Style 1800-0822  
Work Order 888

Info Page

Back View: Cutout

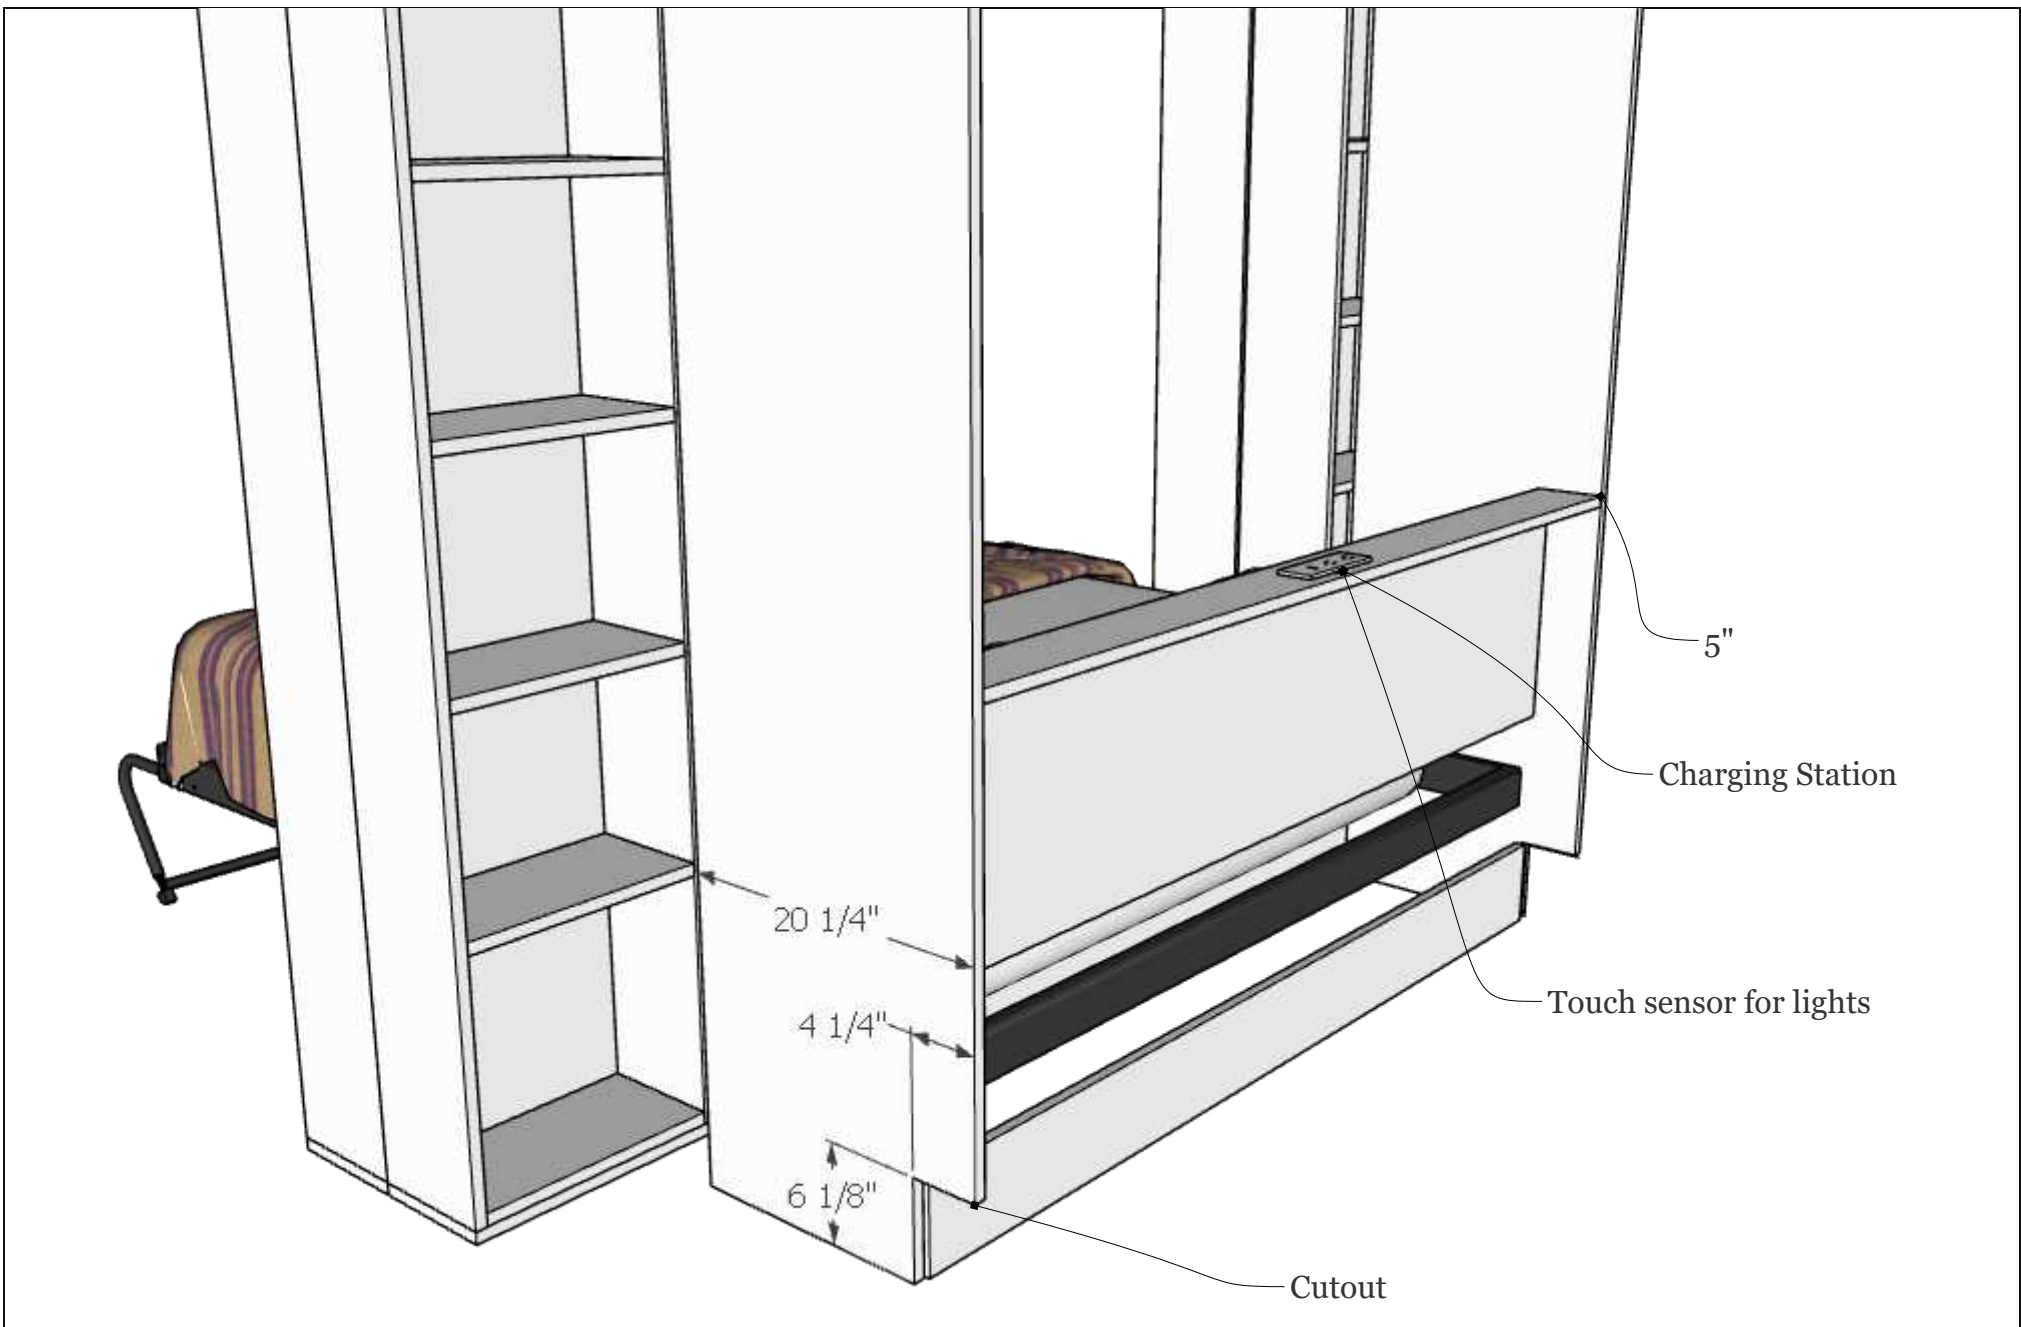
Customer has a protrusion on the lower part of the wall (4"d x 5.5"h).  
 Made cutout 4 1/4" x 6 1/8" and overall depth 4" deeper.

MM/DD/YY	REMARKS
1	7/14/22	Changed cutout size and overall depth
2	--/--/--	...
3	--/--/--	...
4	--/--/--	...
5	--/--/--	...
